Agenda
Village of Arlington Heights
Design Commission
Community Room, 3rd Floor
Arlington Heights Village Hall, 33 S. Arlington Heights Rd.
February 27, 2024
6:30 PM

MINUTES OF THE VILLAGE OF ARLINGTON HEIGHTS DESIGN COMMISSION

– It is recommended that the Design Commission evaluate the design of the proposed addition at 1010 N Wilshire Lane. This recommendation is based on the architectural plans received on 2/2/24, and the following:

It is recommended that the Design Commission evaluate the proposed architectural design for the new (teardown) single-family home to be located at 1138 N. Chestnut Avenue. This recommendation is subject to compliance with the architectural plans received 1/18/24, Design Commission recommendations, compliance with all applicable Federal, State, and Village codes regulations and policies, the issuance of all required permits, and the following:

SHEET TITLE
EXISTING DRAWINGS

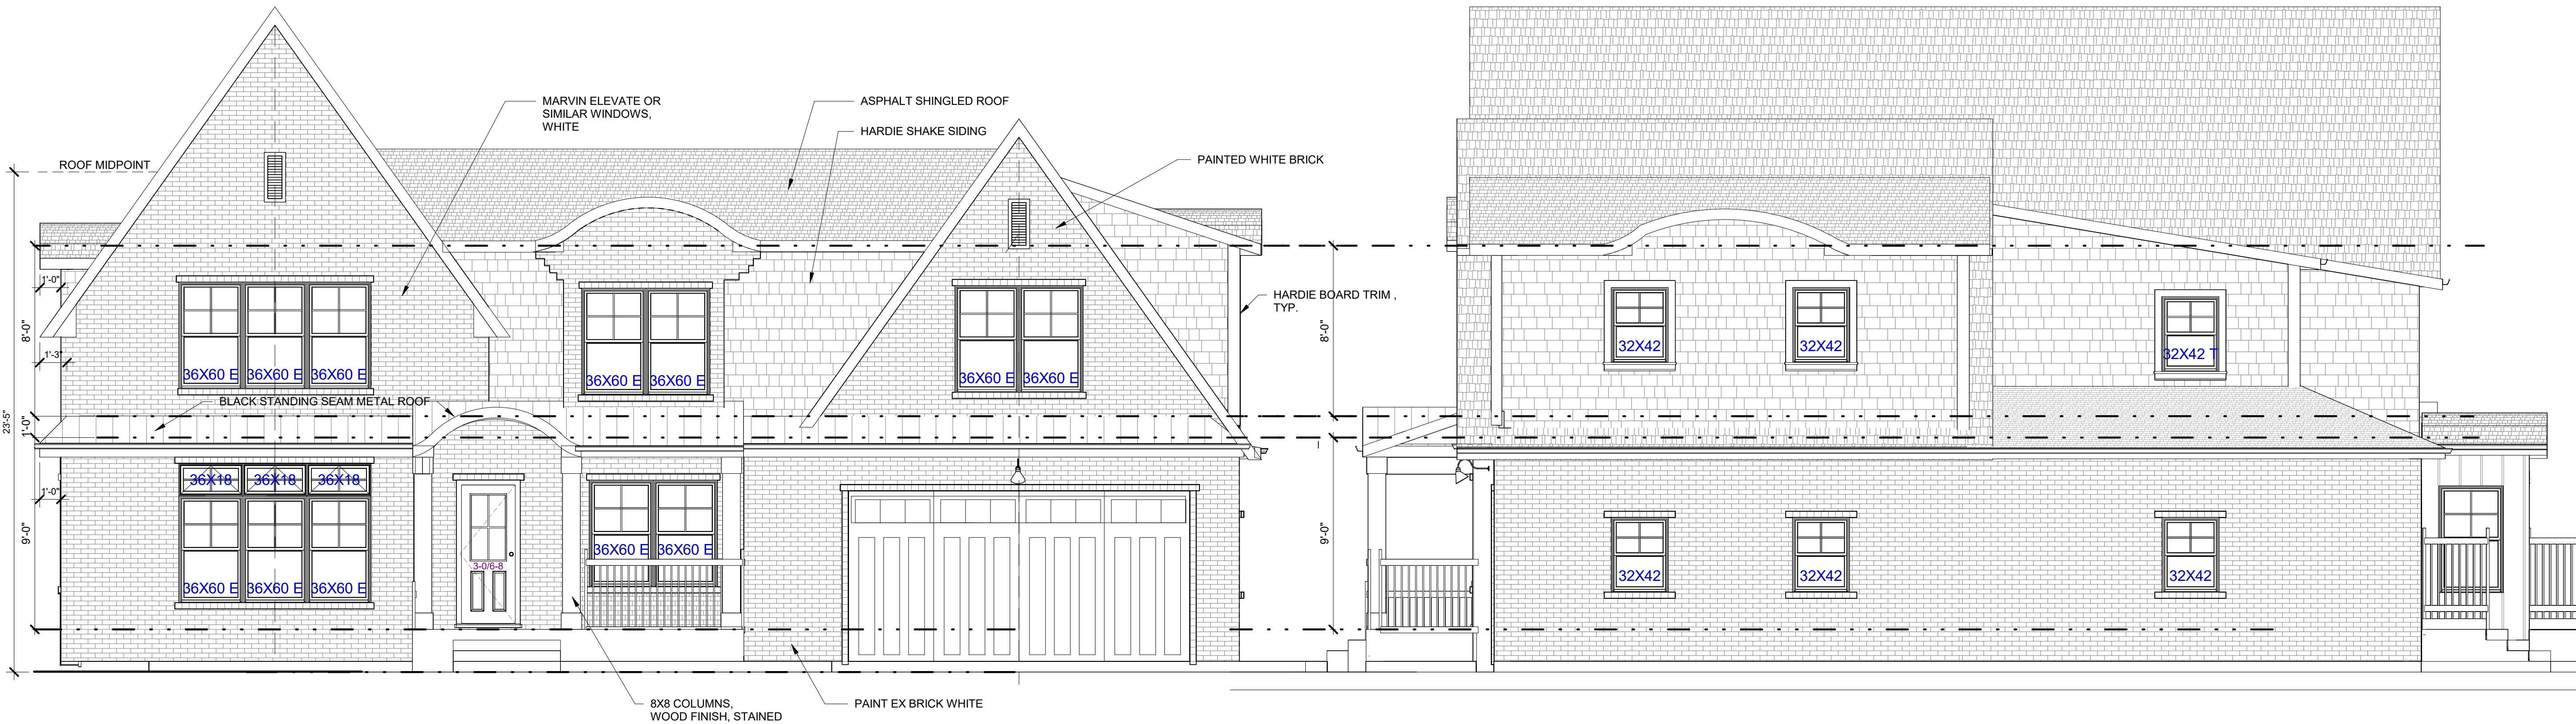
Overall, the proposed design, materials, and colors do not fit with the existing context of the block. The tall steep pitched roofs are a harsh contrast to the adjacent low sloped roofs. A revised simpler design with low pitched roofs and a more earth tone color palette is encouraged to better fit with the existing context of the block.

It is recommended that the Design Commission evaluate the design of the proposed addition at 1010 N Wilshire Lane. This recommendation is based on the architectural plans received on 2/2/24, and the following:

1. A revised simpler design with low pitched roofs and a more earth tone color palette is encouraged to better fit with the existing context of the block.
2. This review deals with architectural design only and should not be construed to be an approval of, or to have any other impact on, any other zoning and/or land use issues or decisions that stem from zoning, building, signage or any other reviews. In addition to the normal technical review, permit drawings will be reviewed for consistency with Design Commission and any other Commission or Board approval conditions. It is the petitioner's responsibility to comply with the Design Commission approval and ensure that building permit plans comply with all zoning code, building permit, and signage requirements.
3. Compliance with all Federal, State, and Village codes, regulations and policies.

SHEET TITLE
ELEVATION STUDIES & NOTES

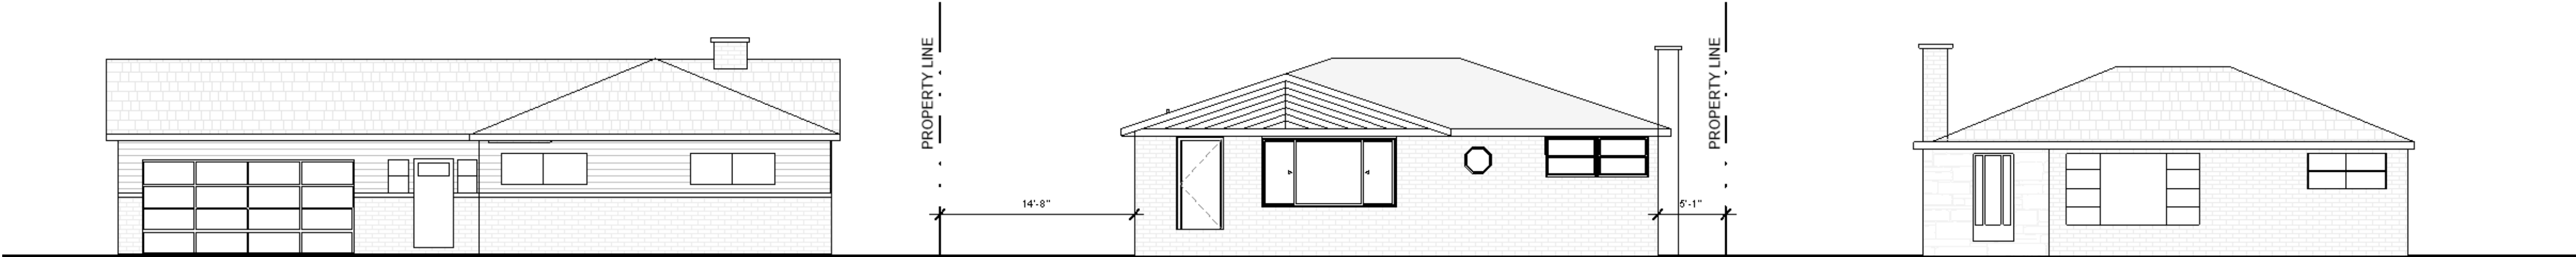
It is recommended that the Design Commission **evaluate** the proposed architectural design for the new (teardown) single-family home to be located at 1138 N. Chestnut Avenue. This recommendation is subject to compliance with the architectural plans received 1/18/24, Design Commission recommendations, compliance with all applicable Federal, State, and Village codes regulations and policies, the issuance of all required permits, and the following:

1. A recommendation to fully hip the left (south) side of the roof.
2. A recommendation to change the proposed black and white color palette to a more neutral earth tone color palette such as tan or taupe siding, with white trim, brown roofing, white windows, white gutters and downspouts, and brick or stone accents to better fit with the context of the adjacent homes.
